**SHEARON HARRIS NUCLEAR POWER PLANT, UNITS 2 AND 3
DOCKET NOS. 52-022 AND 52-023
RESPONSE TO REQUEST FOR ADDITIONAL INFORMATION LETTER NO. 049 RELATED TO
MANAGEMENT AND TECHNICAL SUPPORT ORGANIZATION**

**Shearon Harris Nuclear Power Plant Units 2 and 3
Response to NRC Request for Additional Information Letter No. 049 Related to
SRP Section 13.1.1 for the Combined License Application, dated November 18, 2008**

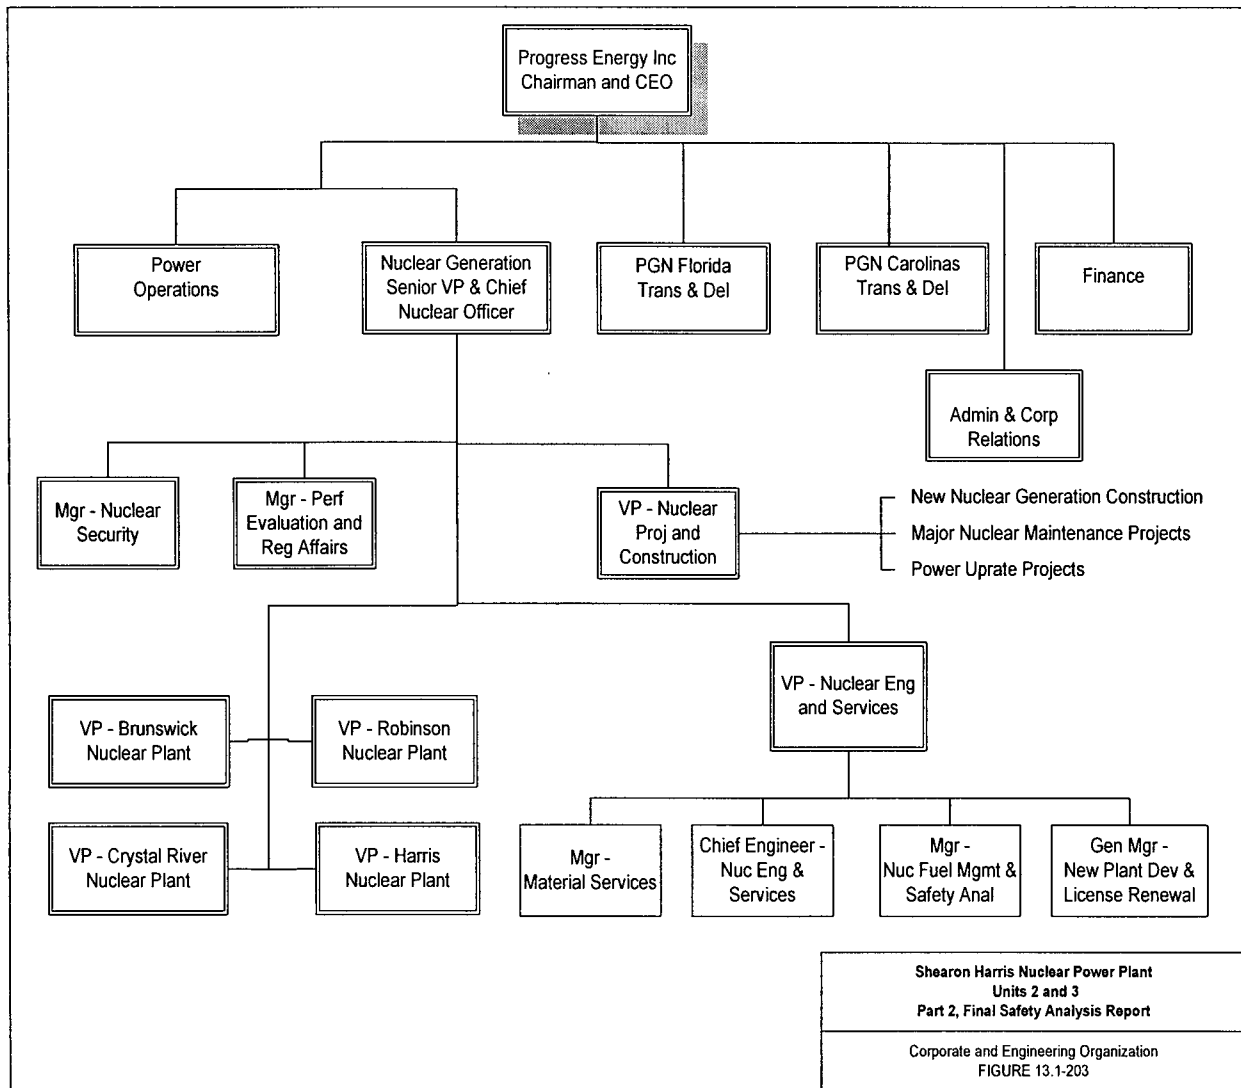
SRP 13.1.1 I.2.B requests, the SAR should provide, with verification through the Construction Inspection Program, the relationship of the nuclear-oriented part of the organization to the rest of the corporate organization.

To clarify how the nuclear-oriented part of the corporation (NGG) relates to the other major corporate departments of Power Operations, Transmission & Delivery, Administration & Corporate Relations, and Finance, organizational links will be added to Figure 13.1-203.

Revise Figure 13.1-203 to include functional organizational links showing how the Nuclear Generation Group (NGG) relates to the other major corporate departments as shown below:
